FINAL PLAT ELIZABETH'S ADDITION

Re: S/D 91-12 (Final Plat) Elizabeth's Addition

**STAFF REPORT
(FINAL PLAN)**

S/D 91-12 - ELIZABETH'S ADDITION

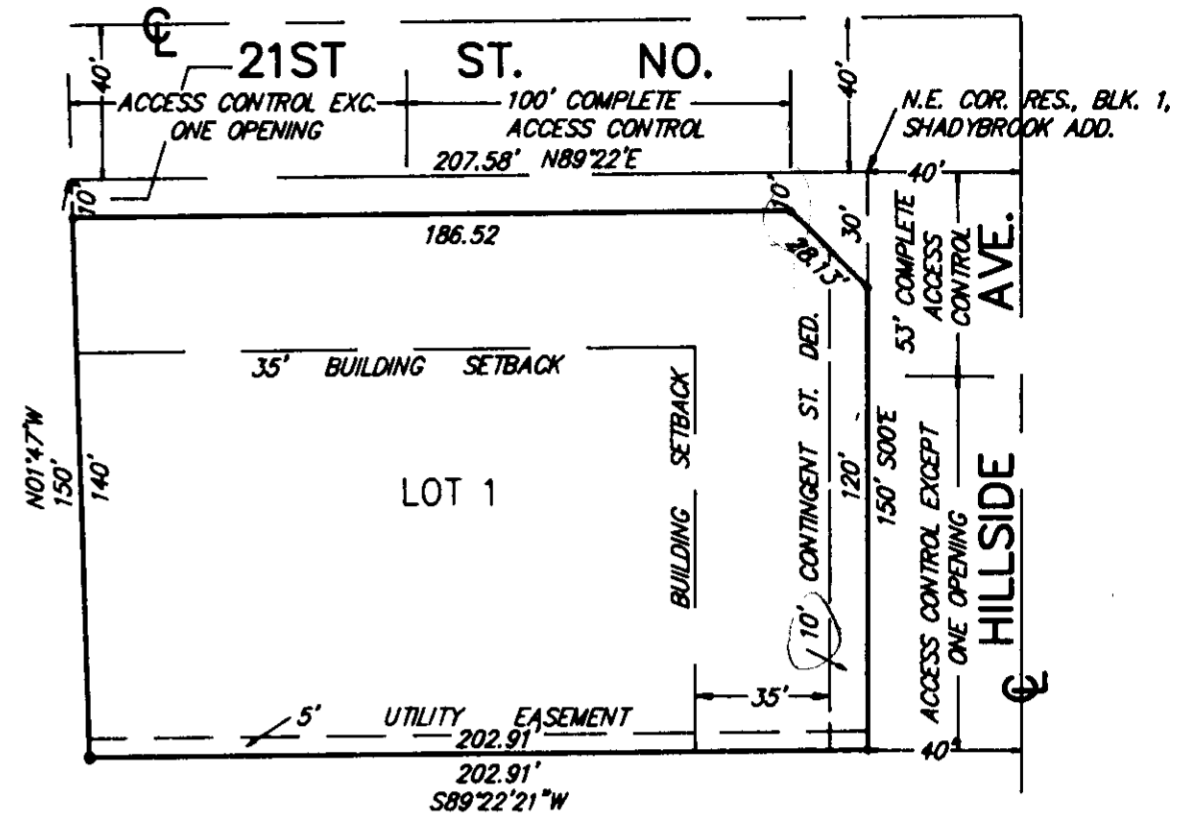
building setbacks do not preclude the property owner from maintaining or remodeling that portion of the building within the setback area. The building cannot, however, be enlarged within the setback and, if the building is removed, any new building construction must observe the platted building setback.

- J. Presently, one of the owners of this site is indicated as J. and Viola Chenn. The final plat tracing shall either include these owner's signatures or a revised title policy will need to be submitted indicating the change in ownership, as now shown on the plat (Julius and Lois Smith).

- N. Perimeter closure computations shall be submitted with the final plat tracing. Section 5-101(c).
- O. Recording of the plat within 30 days after approval by the City Council.

- A. The applicant shall guarantee the closure of those driveways in excess of the access controls being established for this plat. Specifically, the closure of two drives to 21st Street North, and one drive to Hillside.

- B. The applicant shall submit a guarantee for the provision of a decel lane to serve this site. This guarantee will be held pending determination of whether landscaping improvements along 21st St. North would make such an improvement inappropriate.

- E. Subdivision Regulations state that the right-of-way for inter-sections of major arterials shall be 75-feet of half for a distance of 250 feet from the intersection, tapering to 50-feet of half. Since this is a developed area, 60-feet of half street right-of-way will be required along both 21st St. North and Hillside as indicated by the original Quiktrip 5th Plat.

- F. Prior to submitting the final plat tracing, the applicant shall also meet with Traffic and City Engineering to determine the amount of right-of-way to provide at the plats northeast corner for the 21st and Hillside intersection.

- G. The access control, as shown, may be inadequate for the amount of right-of-way required. The final plat tracing shall indicate 40-feet of complete access control allowing for the additional right-of-way along Hillside from the intersection of the arterial streets.

- H. On the final plat tracing, a 10-foot utility easement shall be indicated along the site's south line. Utilities and sanitary sewer are located in what is presently only a 15-foot easement, 5-feet being on this site and 10-feet on the adjoining property. A 20-foot easement is required.

- I. The final plat shall indicate the platting of the 35-foot building setback from 21st Street North and Hillside through the existing buildings which encroach into the setback areas. Central Inspection has advised that the platting of these
